CITY OF ALBUQUERQUE

October 9, 2018

RE: Maverik Fuel Center
3737 Princeton Drive NE
Grading and Drainage Plan & Drainage Report
Engineer's Stamp Date: 10/03/18
Hydrology File: G16D029

Based upon the information provided in your submittal received 10/03/2018, the Grading & Drainage Plan and Drainage Report **are not** approved for Building Permit and SO-19 Permit. The following comments need to be addressed for approval of the above referenced project:

SHEET #
D1

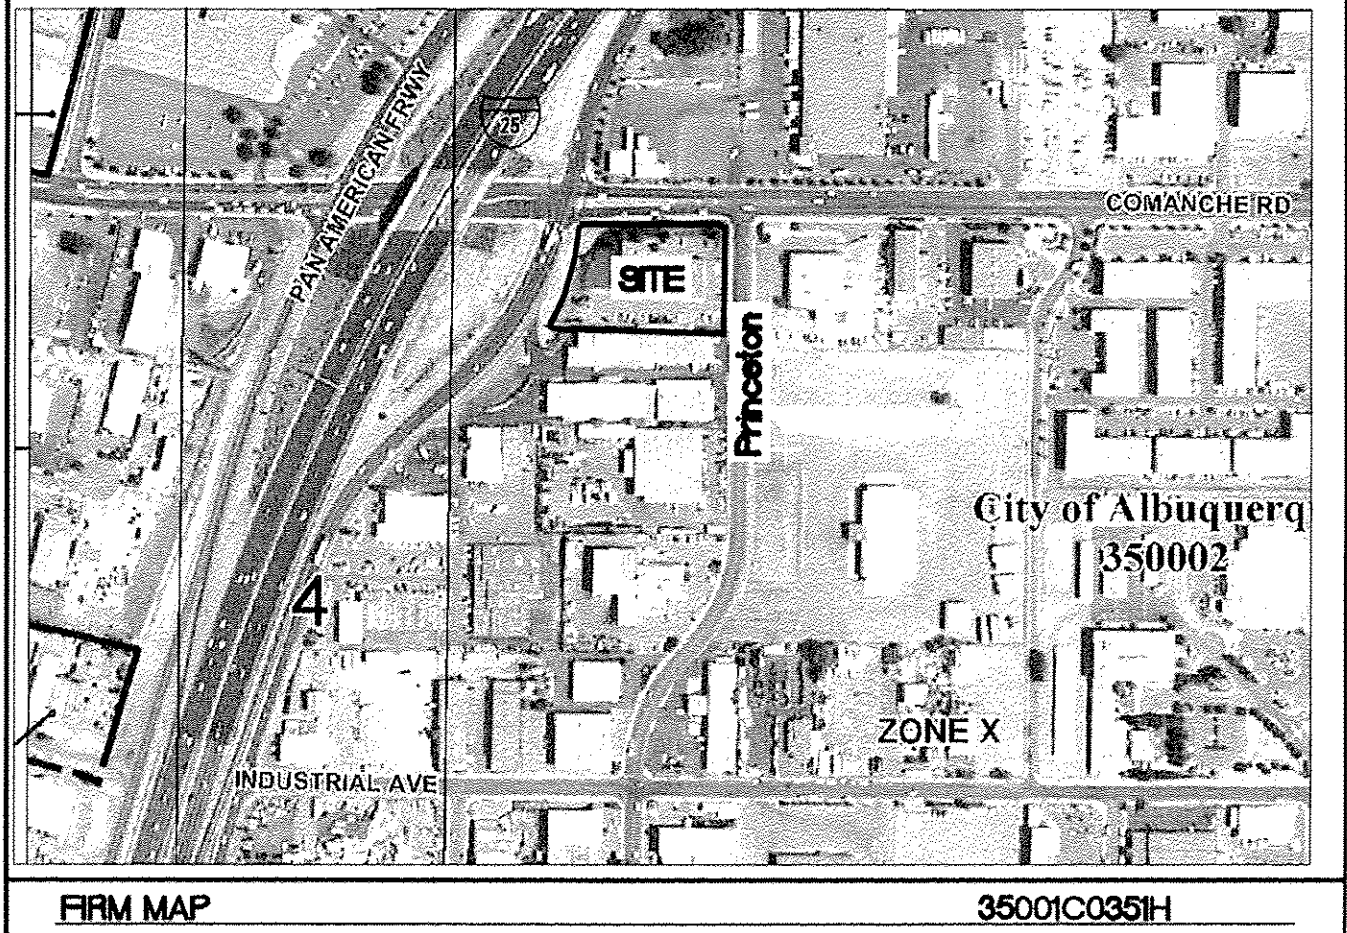
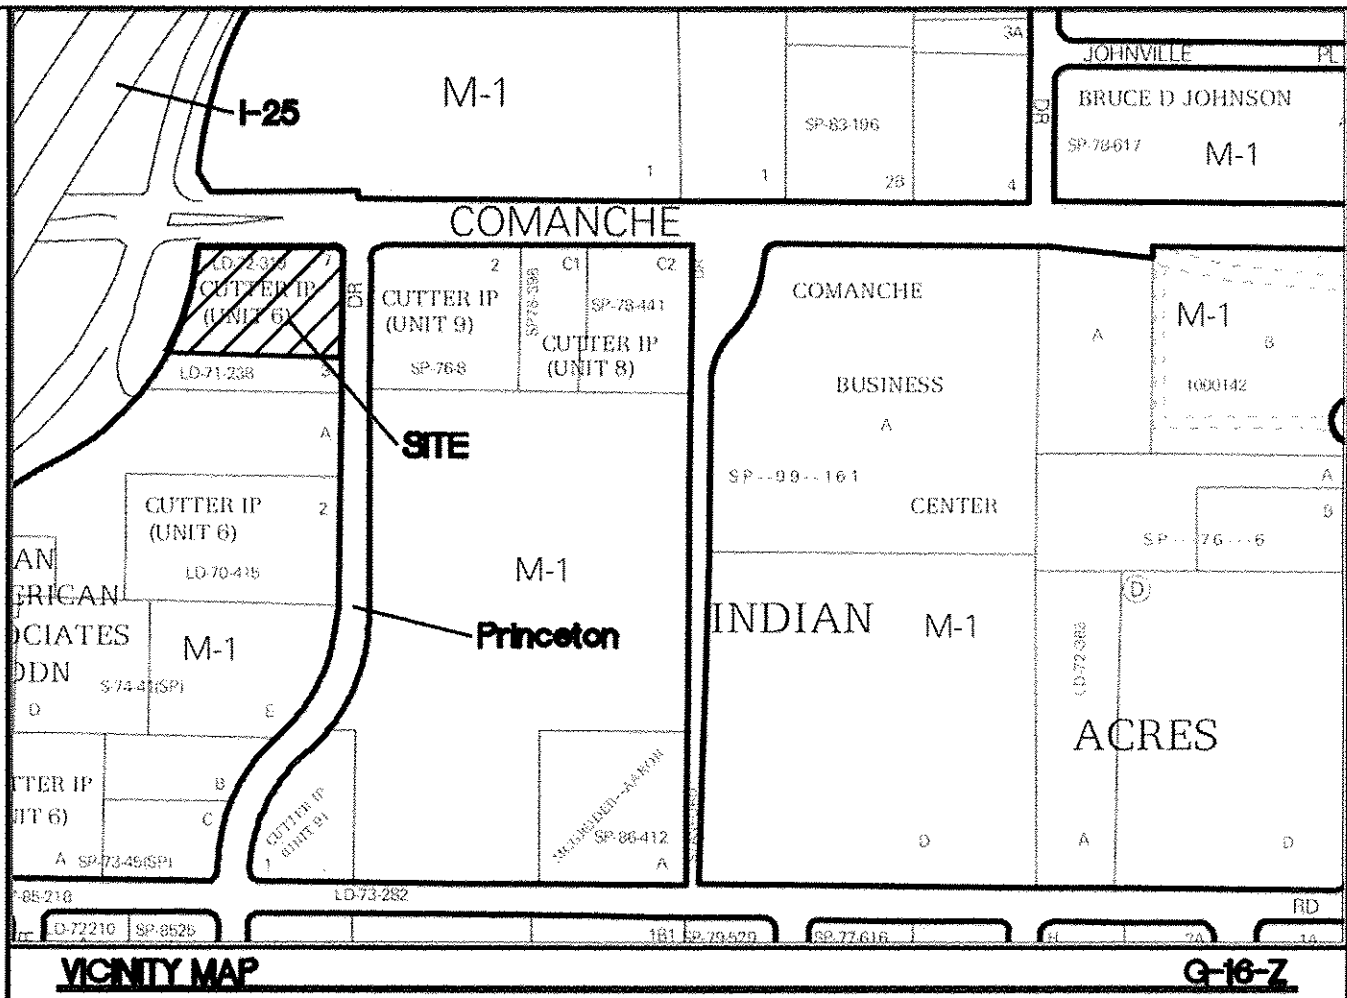
5. Sheet C5. In the water quality pond sections, please change the word "detention" to "water quality".
6. Sheet D1. Please darken the proposed storm sewer pipes so that they can be seen.

7. Sheet D1. Please turn off the accessible path layer. This is not needed on this sheet and is a little confusing with the drainage area lines.
